**MOUNT POLLEY MINING CORPORATION
MOUNT POLLEY MINE
TAILINGS STORAGE FACILITY**

**REPORT ON 1999 CONSTRUCTION
(REF. NO. 11162/13-5)**

2.9 DESIGN MODIFICATIONS

STAGE 2C DESIGN MODIFICATIONS

v/s toe drain original design location
 Detail A (NTS)

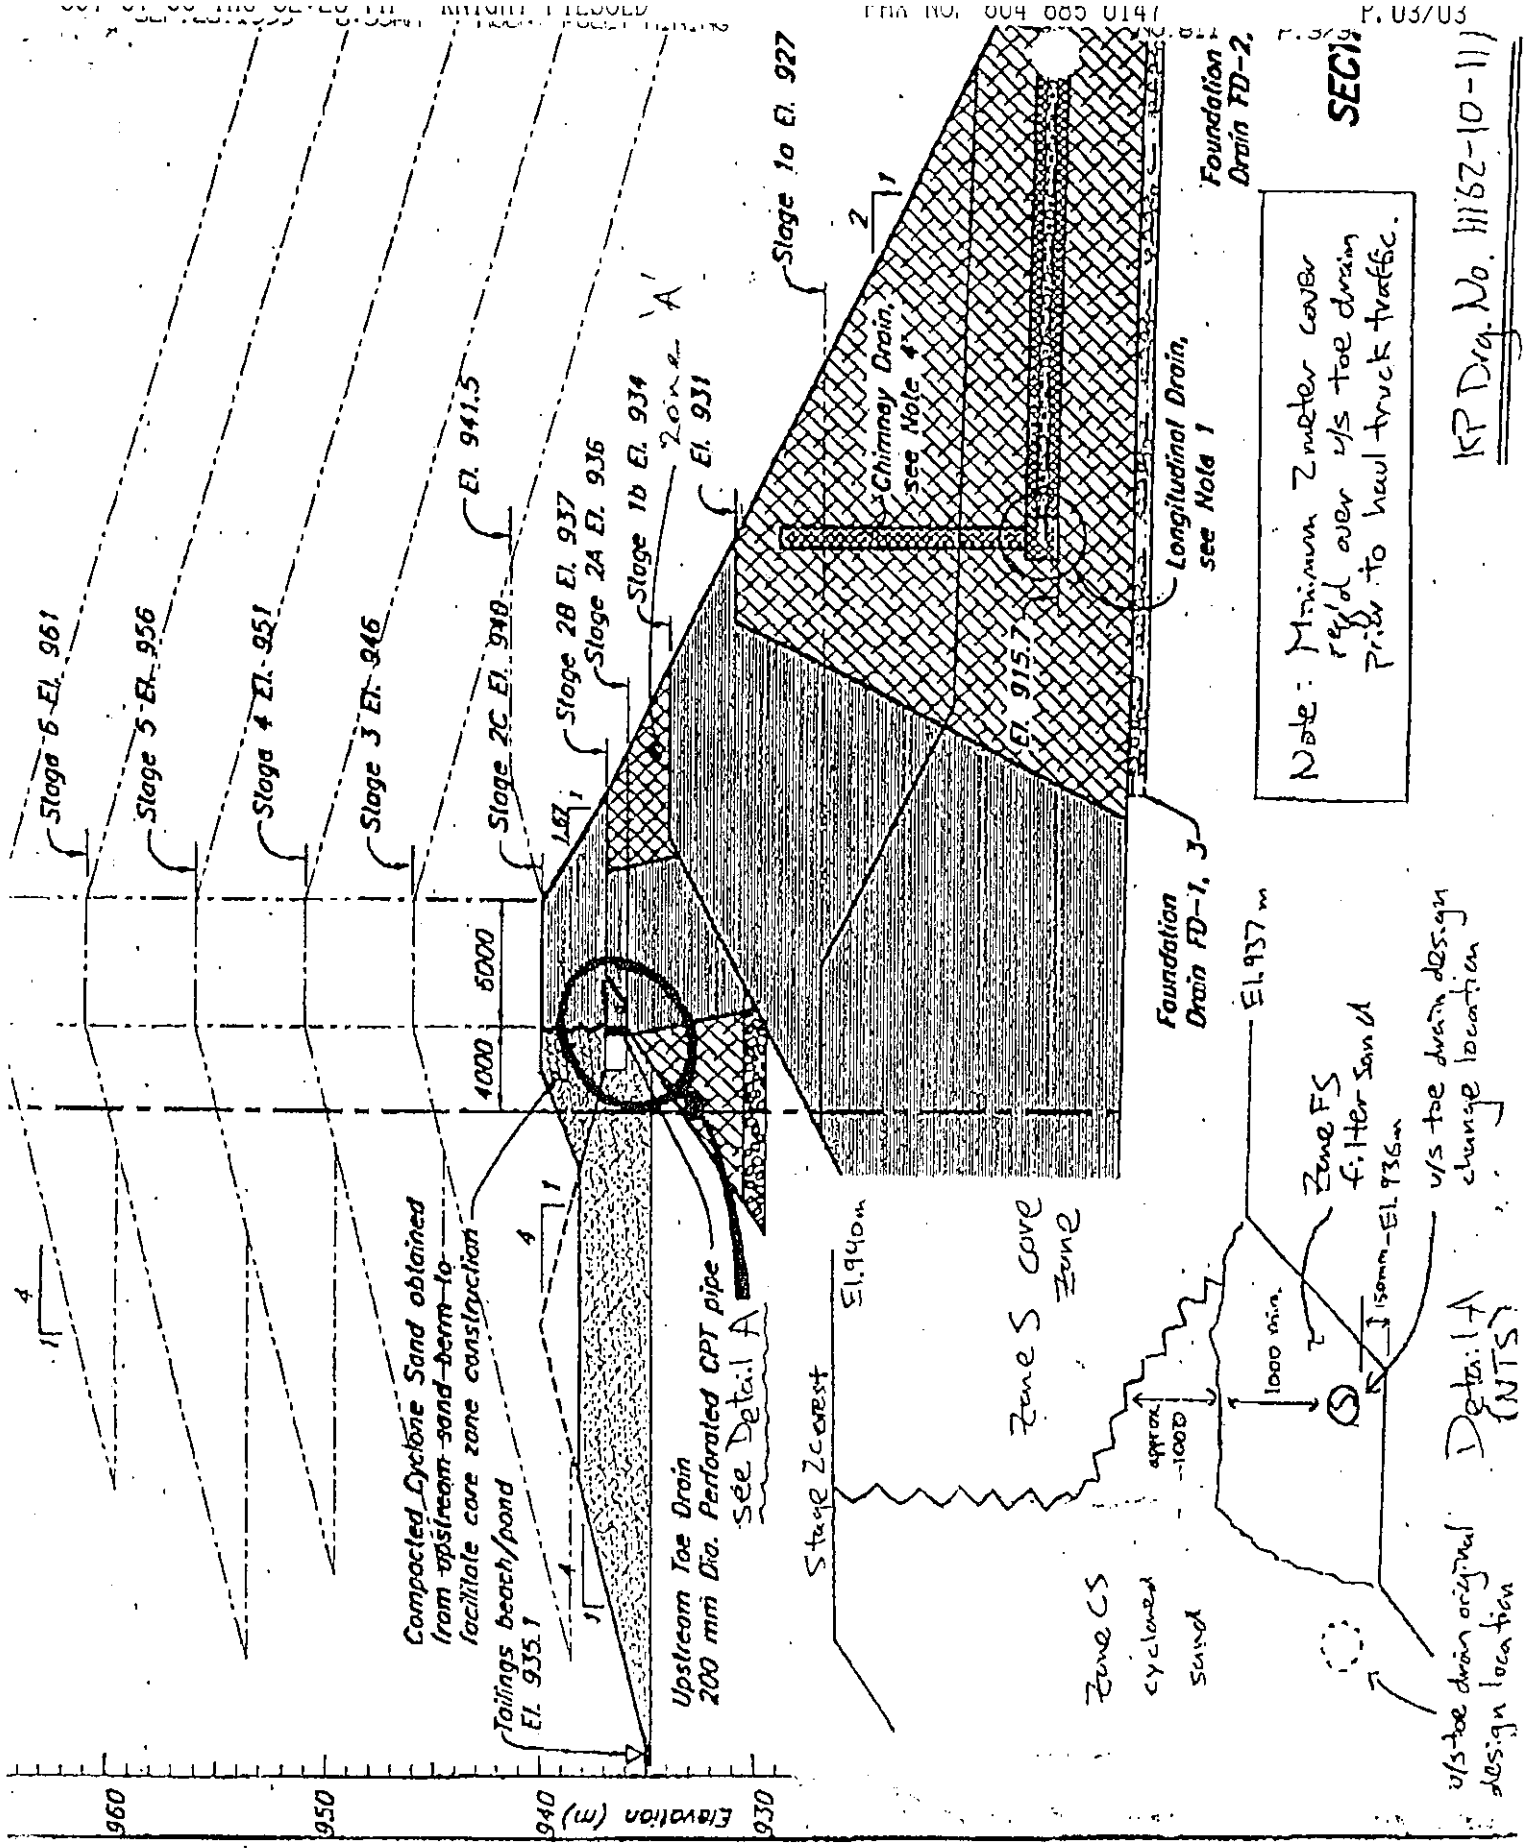
Request for design change re: location of upstream toe drain along Main and Perimeter Embankments. Toe drain to be relocated downstream of original design location, above Stage 2A u/s bench. Toe drain pipe to be bedded above 150mm layer of Zone FS filter sand, with a minimum 1000mm of Zone FS filter sand above pipe. Nominal ~~total~~ compaction to be carried out around with vibratory roller following placement of 100mm Zone FS above pipe. The Zone CS cycloned sand / Zone S core contact to initially slope upstream such that approximate Please review the proposed change / substitution as per the attached sheets. 1000mm of Zone CS exists above pipe. This contact will then extend vertically upward to allow for the designed 6m wide Stage 2C crest @ El. 940m.

The attached three design changes have been approved with one amendment. The vertical risers that were proposed for the upstream toe drain outlets introduce too much rigidity in the system and the pipe could shear under differential settlement. Instead, a "sweeping bend" could be used to accommodate elevation differences. The sweeping bend or horizontal elbow are flexible in the plane of expected forces and would accommodate settling without damage to the pipe. This need for making up an elevation difference between the toe drain and the outlet should not be required any more as the toe drain is going to be installed first at a known elevation (936 m) and the outlet should, therefore, be installed accordingly. You should send in a design change request for the revised upstream toe drain installation as I discussed with Eric yesterday.

MOUNT POLLEY MINING CORPORATION
 MOUNT POLLEY MINE
 STAGE 2C CONSTRUCTION
 MAIN AND PERIMETER EMBANKMENT
 APPROX. CH 26+80 TO CH 32+00

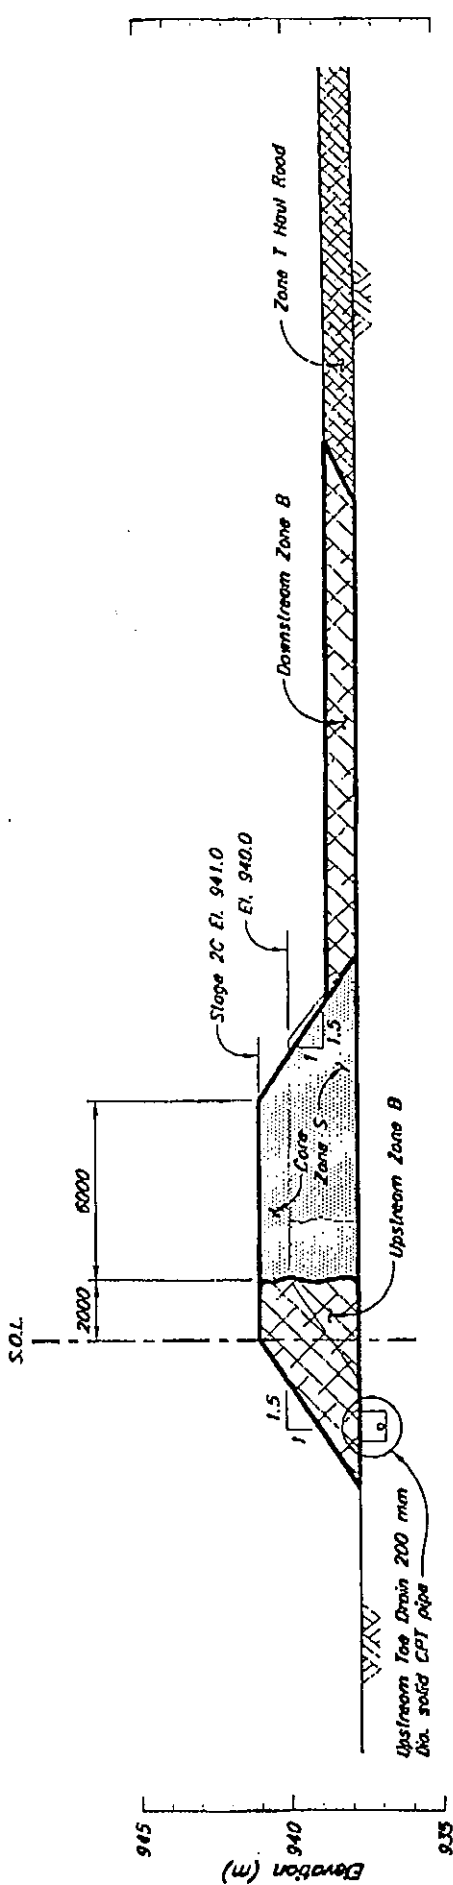
Reference Drawings/Clauses: Figure 1 - Main Embankment (±CH 15+60 to 26+80)
Figure 2 - Main & Perimeter Embankments (±CH 26+80 to 32+00)
Figure 3 - Perimeter Embankment (±CH 32+00 to 44+35)

- As shown on your design change request, Zone B material will be placed and compacted to replace the u/s cycloned sand fill for Stage 2C Perimeter embankment construction. The Zone B crest will extend 2 metres u/s of the Zone B/S contact, and will be constructed with a 1.5H:1V u/s face slope.

- A section of the perforated upstream toe drain has been temporarily removed from the design, along the length from the Perimeter embankment left abutment to approximate CH 33+00. As shown on the original design, this perforated drain is to be located between the Perimeter embankment u/s toe drain outlet pipe locations, as shown on KP Drawing No. 11162-10-120. During future construction, this section of u/s toe drain will be reinstated adjacent to u/s cycloned sand materials.

FIGURE 1

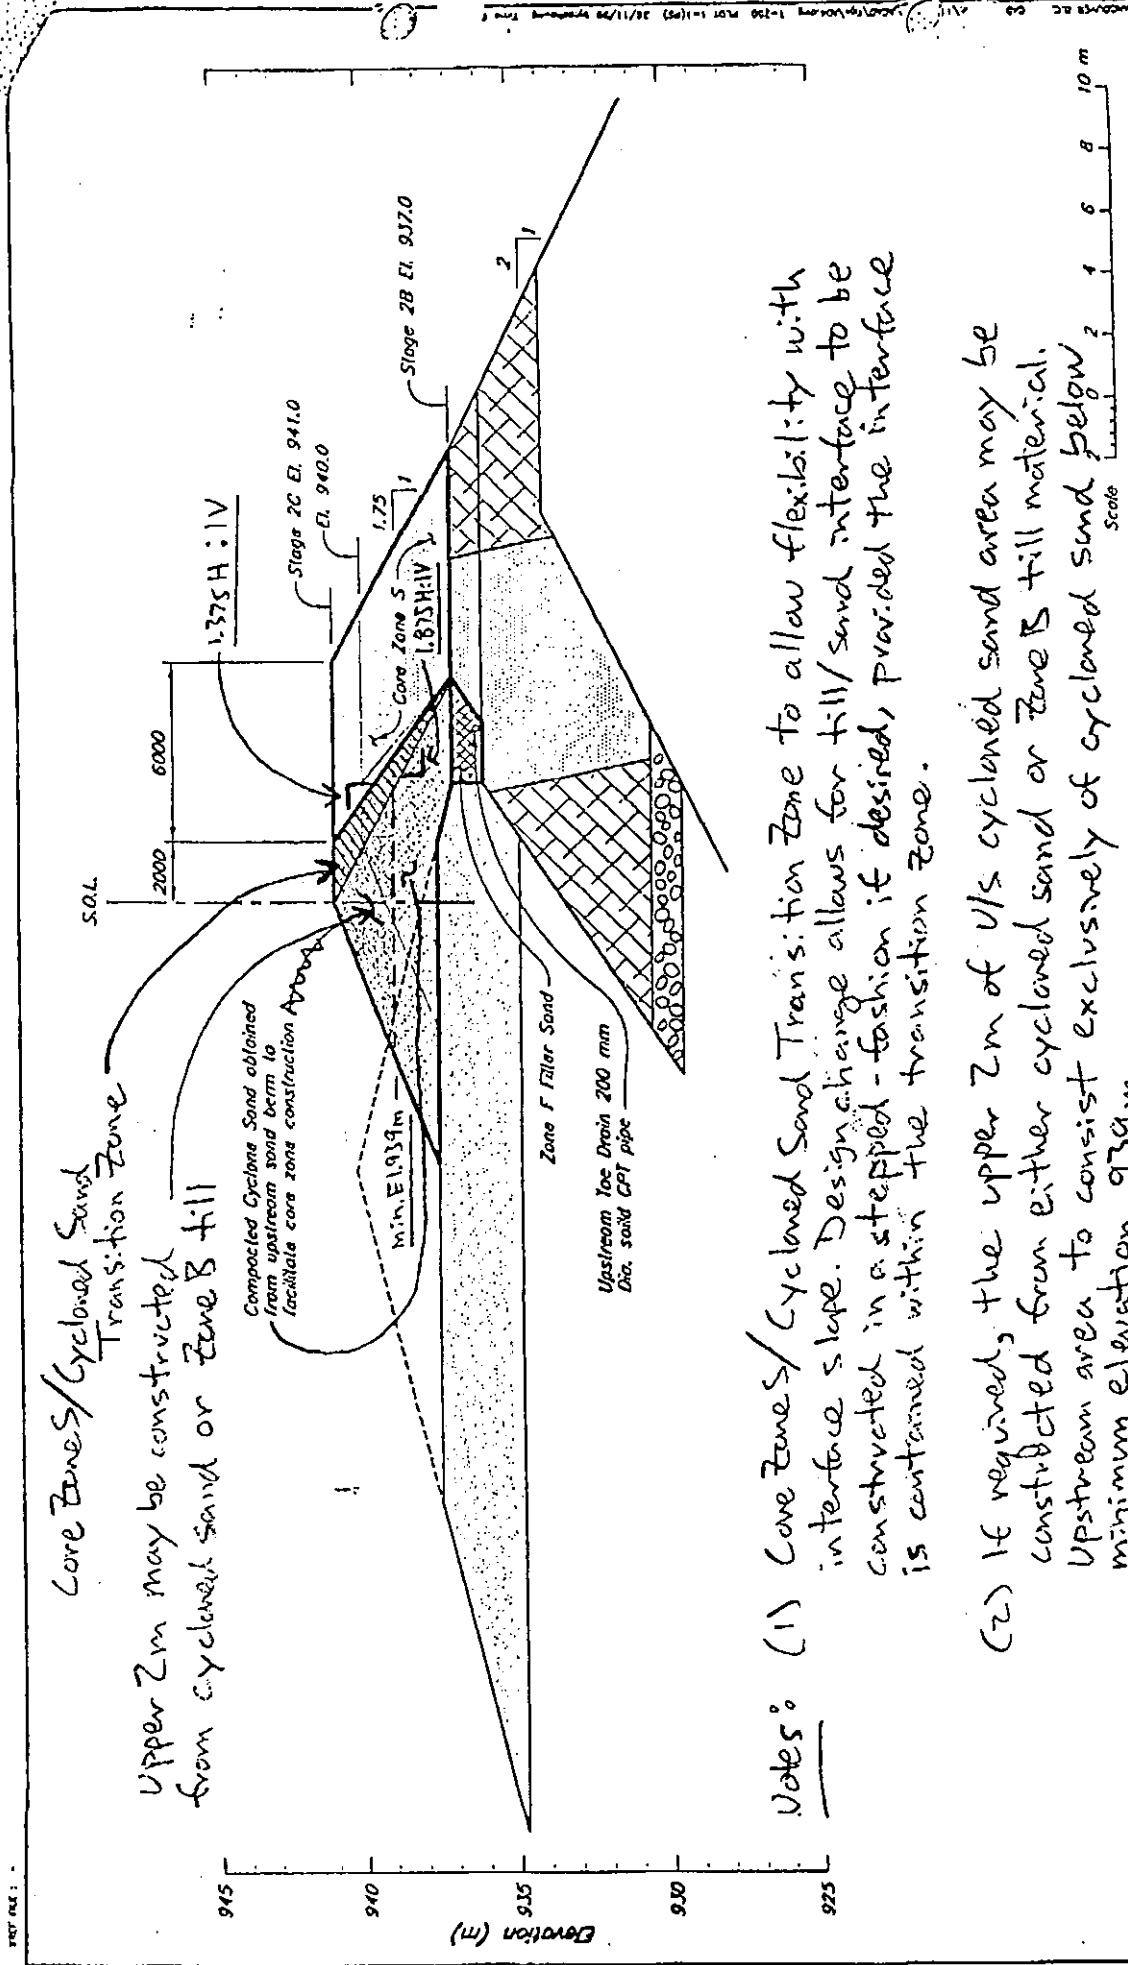
Reference Drawings / Clauses: Figure 1 Rev. 0 of Design Change, issued by KP Vancouver (Nov 26/99, Ref No. 9/2771)
